<b>SERVICE BULLETIN</b>	model number	ALL	bulletin number	00011
	for serial numbers	ALL		
	subject	DRIVER BOARD TRANSISTORS		
	technical services approval	J. R. Thomas	writer	Melvin W. Mason
engineering approval	J. Blum	date	4/13/79

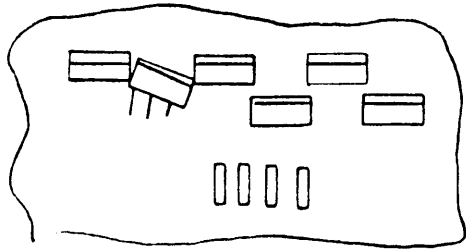
New larger driver transistors have been substituted as a running change on right/left and center driver board PN 100-04D0-035 and 100-04D0-045. Symmetrical appearance of the transistors which are mounted on the boards is not necessary for optimum operation. Do not attempt to straighten out or reposition the transistors on the driver board which may be bent over or out of line. If the components are not touching and are more than 1/32" from other parts, **LEAVE THEM ALONE**. Do move the transistors only if the metal power tab protruding out of the top of the transistor is touching one of the other transistors or components on the circuit board. If the transistor must be moved, it should be moved in a direction which will eliminate contact with other components and which will not cause stress to the legs of the transistor. **REMEMBER**, the metal power tab has 180 VDC applied to it during normal operation. The diagram on the other side of this bulletin illustrates both types of mounting arrangements for the power transistors, i. e. at right angles with the other components and a 45° angle. **NOTE:** If it becomes necessary to reposition the transistors, follow these guide lines:

WRONG  
TRANSISTOR TOUCHING  
OTHER COMPONENTS

RIGHT  
TRANSISTOR CLEAR OF  
OTHER COMPONENTS

1. Make certain you allow the unit to sit for one minute after power is removed.
2. Do not flex the transistors back and forth to position them. If at all possible bend them only once into the correct position.
3. Bend the transistors back to front only, not side to side if possible, this reduces chances of damaging the leads.
